SEWAGE DISPOSAL TESTING

STATE OF MARYLAND - DEPARTMENT OF HEALTH AND MENTAL HYGIENE

DISTRICT 5th
DATE 9/21/79

SUBDIVISION Williams Contrivance Estates LOT NO. 16, Sec. 2

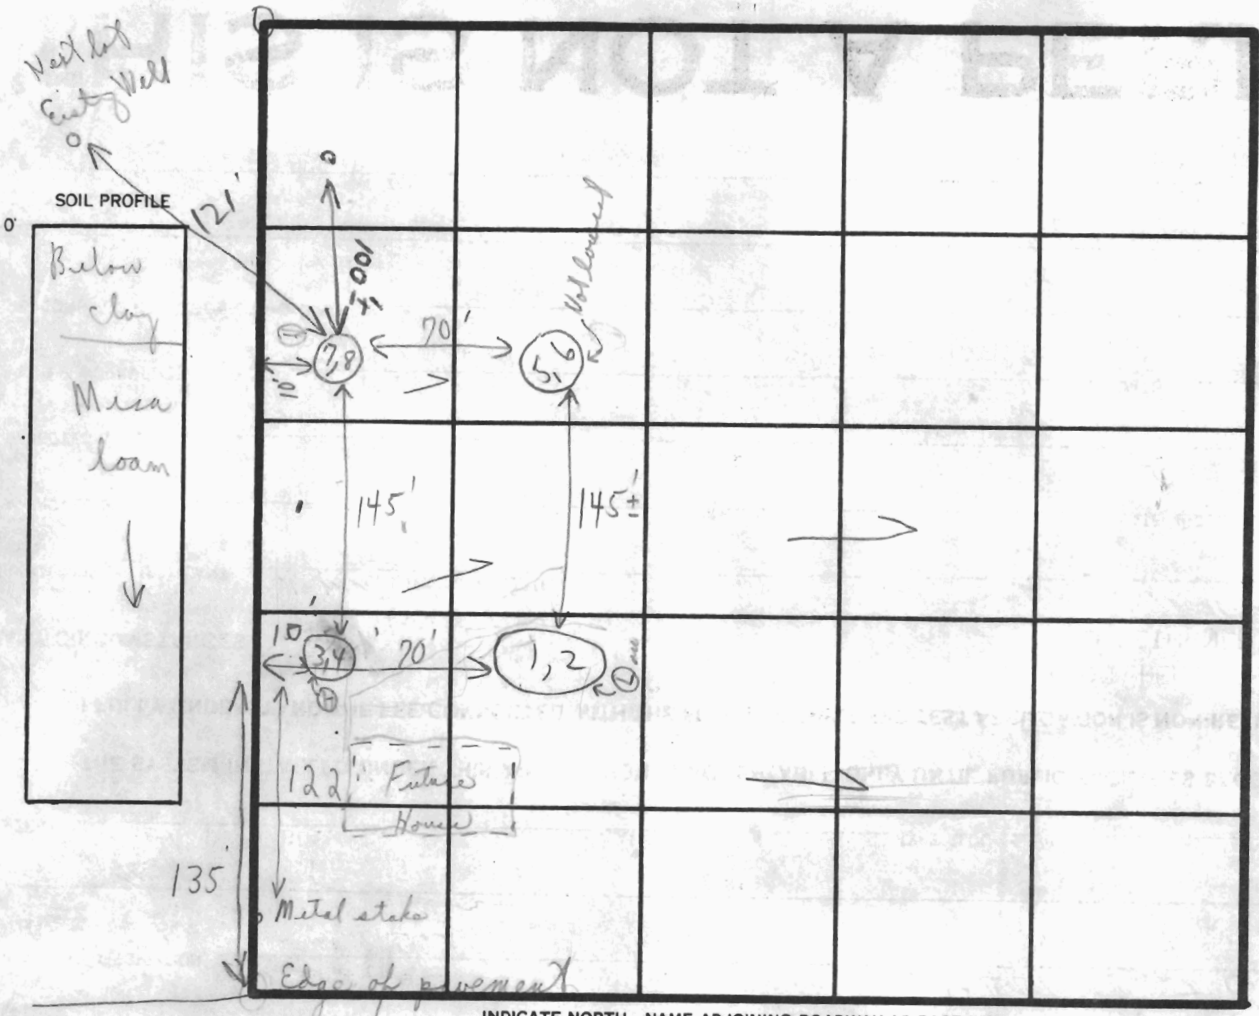
REASONS FOR ~~PERC~~ HOLDING 9/25/79 Wet season tests if supervisor feels necessary
Water Table; house site; well location

+ for supervisor. If not approved - recommend go back to original area. C.B.S. 9/25/79 Office Discussed (with Mr. Frommelt + F.F. See attached.

12/79 See attached. Wait for wet season +/or go to original area. C.B.S. + F.F. See attached.

Tested with Mrs Culver knowing lot may not be open. Tests in open field. Hold for supervisor on

Hold for wet season. (1) No Perc in water, (2) Need to know well location, and amount of water in soil in front. Mrs Culver

Tile Field - 133 sq ft bottom area per bedroom to be installed at a depth of 4ft below orig. grade. Each trench to have one ft of gravel and no trench to exceed 100' in length. Trenches to be connected to dist. box & follow contour of ground.

Start Trench #1 Place Tile Field 135' from front lot line and 10' from left side line. rest of trenches to be left of tank right

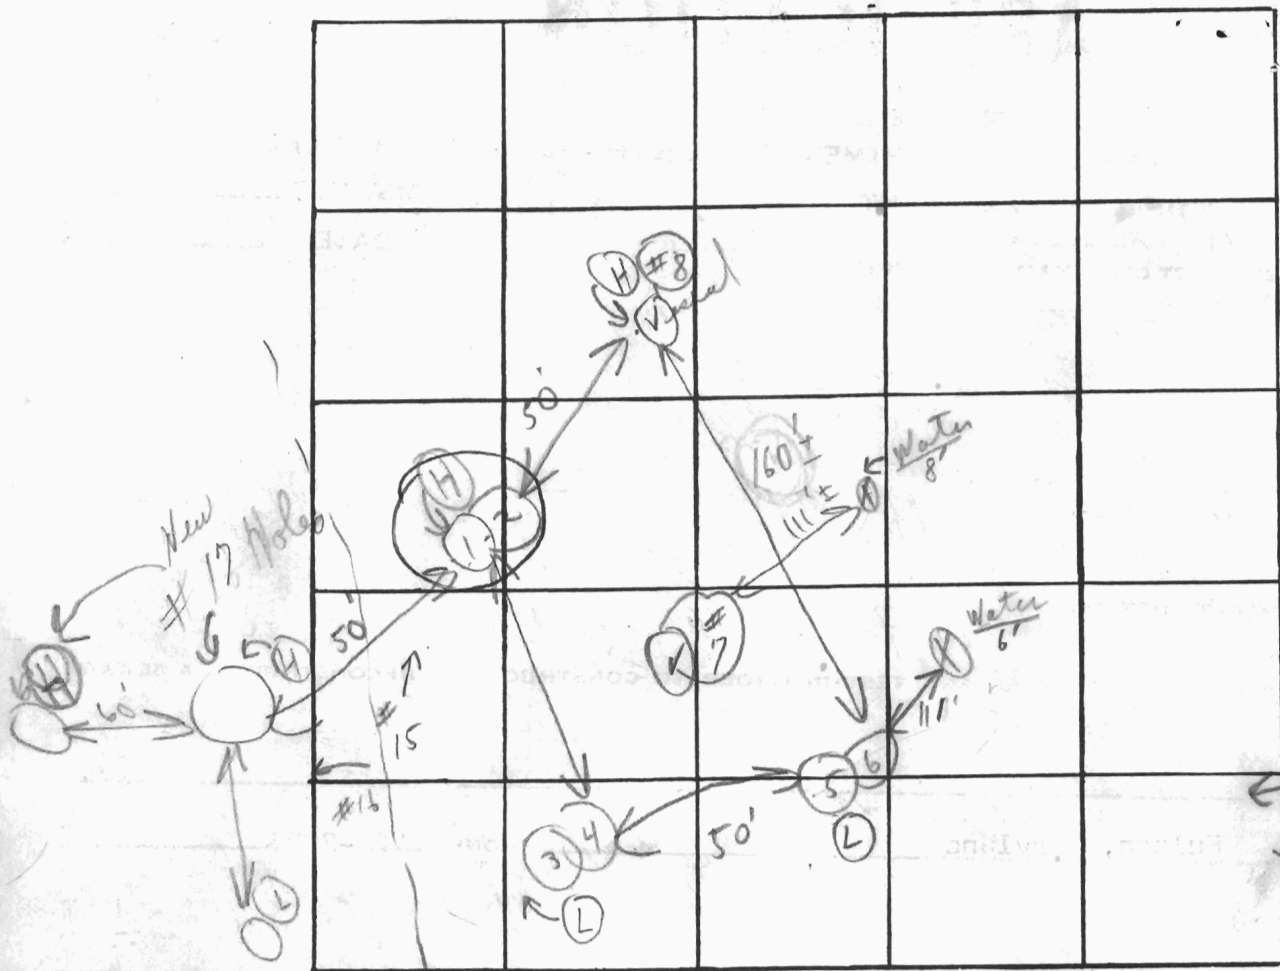
*check to see if 7/25/76
pre-area has been
cut down. 9/18/79
before signing bldg permit.*

New
 Test #16
 line
 tests being
 changed
 Balend
 in
 field
 125 yd ft.
 effective
 Valid 4'
 5' good ground
 6 min

*absorbent sidewall area per bedroom
first 5' of original soil
to be 4' below original
grade and maximum depth 12'.
10' off left property line + 180' from left
rear corner line when facing lot
from Howard Road.*
